**SUBJECT: CALLAWAY PLANT - NRC INTEGRATED INSPECTION
REPORT 05000483/2006003**

Docket: 50-483
License: NPF-30
Report No.: 05000483/2006003
Licensee: Union Electric Company
Facility: Callaway Plant
Location: Junction Highway CC and Highway O
Fulton, Missouri
Dates: March 25 through June 23, 2006
Inspectors: M. S. Peck, Senior Resident Inspector
D. E. Dumbacher, Resident Inspector
R. E. Lantz, Senior Emergency Preparedness Inspector
D. L. Livermore, Reactor Inspector
B. K. Tharakan, Health Physicist
Approved By: W. B. Jones, Chief, Project Branch B

IR 05000483/2006003; 03/25 - 6/23/2006; Callaway Plant: Heat Sink Performance, Operator Performance During Nonroutine Evolutions and Events and Operability Evaluations.

Figure 1
Containment Heat Exchanger

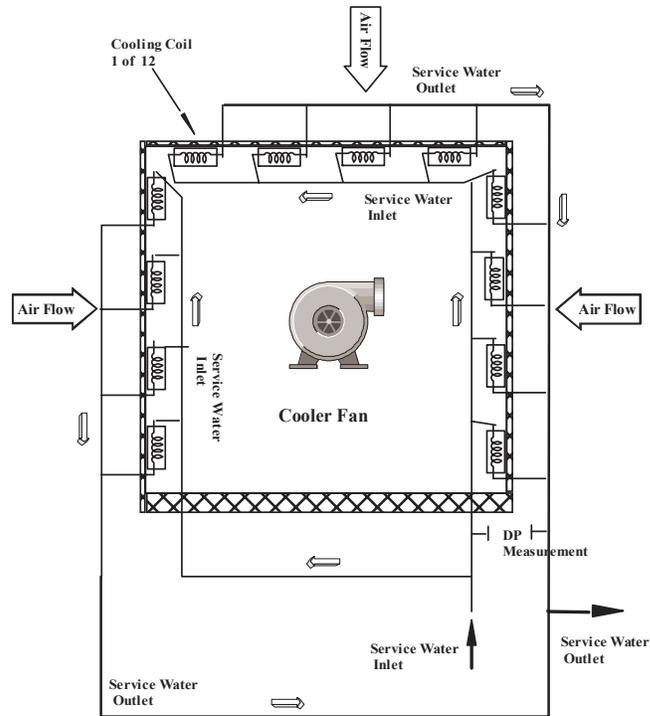
Description: The inspectors identified that AmerenUE had not adequately demonstrated, through performance, flow and differential pressure testing, that the containment heat exchangers would perform acceptably following installation. The Callaway Plant has two containment heat exchangers in each containment cooling train. Each train is required to remove 141×10^6 British thermal units per hour (BTU/hr) under accident conditions. AmerenUE performed containment heat exchanger replacements during Refuel Outages 11 and 12. Each new containment heat exchanger consisted of 12 parallel coils, 8 coils arranged across one service water supply header, and 4 coils across a second header (Figure 1). The postmodification testing requirements, established by Testing Requirements Determination Record 00-1018, Revision A, included:

The performance test used the Temperature Effectiveness Method to verify that the new containment heat exchangers were capable of removing the required postaccident heat load. The flow verification test used the Differential Pressure Method to verify the service water tube side was free of flow obstructions. The in-service test verified minimum service water flow was available for each containment heat exchanger. The inspectors identified that the performance test acceptance criteria was not met for two containment heat exchangers. Procedures ETP-GN-0001A and B established a minimum of 80 percent heat transfer effectiveness. The inspectors identified that the test conditions for the other two containment heat exchanger performance tests were not appropriate. In both cases the air leaving the containment heat exchangers was warmer than the air entering the containment heat exchangers. The absence of a heat load across the containment heat exchangers invalidated the test results. AmerenUE

The inspectors identified that AmerenUE failed to establish acceptance criteria for the flow verification test. The flow verification test used the Differential Pressure Method to verify no tube side flow obstructions existed for the new heat exchangers. Plant engineers measured the pressure drop across the header that supplied 8 of the 12 coils. Figure 1 indicates the location where AmerenUE measured differential pressure. The measurement was performed at the same static head on all four new containment heat exchangers. The pressure drop test results, corrected for flow variances, ranged from 20 pounds per square inch differential (psid) to 31.4 psid. The expected value from the manufacturer was 14.5 psid. AmerenUE did not perform an evaluation to address why the test results varied between the newly installed coils or from the manufacturer's expected value. The inspectors identified that AmerenUE did not include differential pressure acceptance criteria into the postmodification test. AmerenUE entered the failures to perform an evaluation of the flow verification test results and provide test acceptance criteria into the corrective action program as CAR 200600012.
